KIT PART NUMBER 3151114

INSTRUCTIONS FOR INSTALLING A REPLACEMENT ICE BANK CABINET CONTROLLER IN A COLDTRON

Figure 1

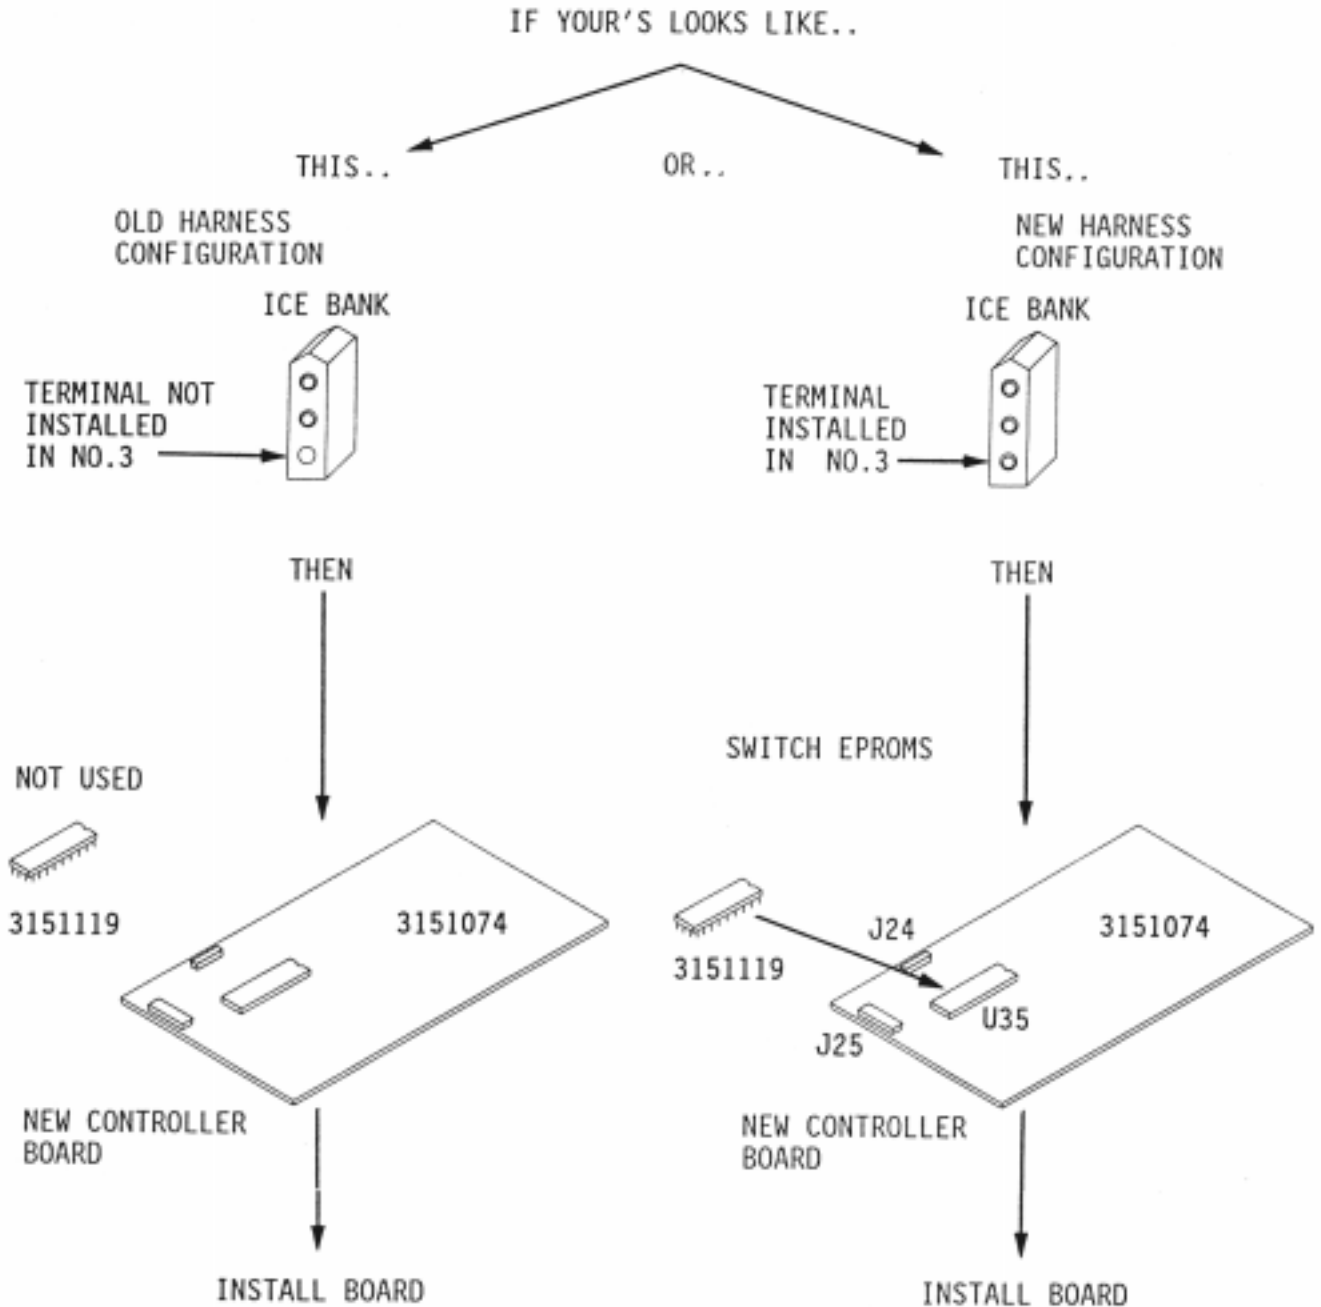
If your merchandiser serial number is 315-020773 or higher, you must replace the EPROM on the controller board supplied in the kit with the 3151119 EPROM. If your serial number is 315-020772 or lower, you use the new controller board as is. However, if you have changed the cabinet harness in your merchandiser to the new cabinet harness you will need to switch the EPROM's according to the directions at the beginning of this note. Refer to Figure 1 to identify your harness if you are in doubt about the configuration.
